UNITED STATES PATENT AND TRADEMARK OFFICE

Office Action Summary

10/540,661

NEIGHBOURS, GREGORY JOHN

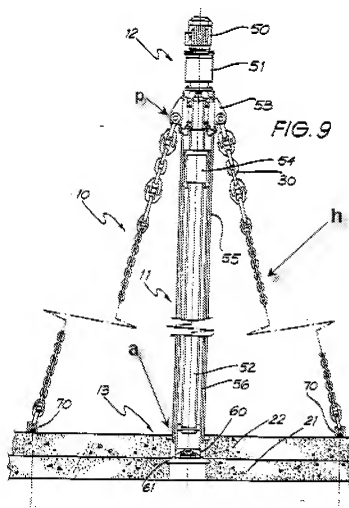
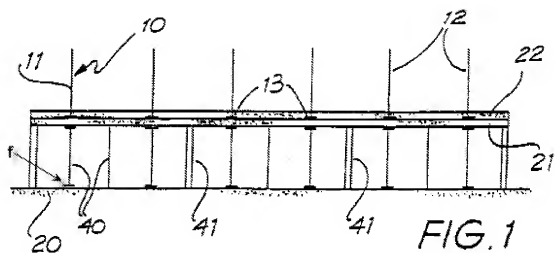
Regarding claim 25, Neighbours discloses a jack (10) for lifting a concrete slab (22), the jack including: at least one shaft (11) and ball screw (52), a drive assembly (12), a hanger assembly (h), a support device (40, 41) wherein the drive assembly drives the ball screw to raise the shaft with respect to the hanger assembly wherein, the support device supports the shaft to prevent toppling and provide stability, (Figure 1, annotated Figure 9);

Regarding claim 26, Neighbours discloses the drive assembly (12) further drives the ball screw (52) to raise the hanger assembly (h) with respect to the shaft (11) such that in use the jack has lifted a slab (22), (annotated Figure 9).

Regarding claim 33, Neighbours discloses each jack (10) having pivoting means (p) such that in use each jack is capable of accommodating displacement of the jack whereby there is a minimum transfer of moment, (annotated Figure 9).

Regarding claim 35, Neighbours discloses the back prop (40) is provided with a foot member (f), and is capable of redistribute any prop loading through the slab in the floor below the jack, (annotated Fig 1). Neighbours does not disclose the foot member being removable. However, it would have been obvious to one having ordinary skill in the art at the time the invention was made to make the foot member removable since it has been held that constructing a formerly integral structure in various elements involves only routine skill in the art. In re Dulberg, 289 F.2d 522, 523, 129 USPQ 348, 349 (CCPA 1961).
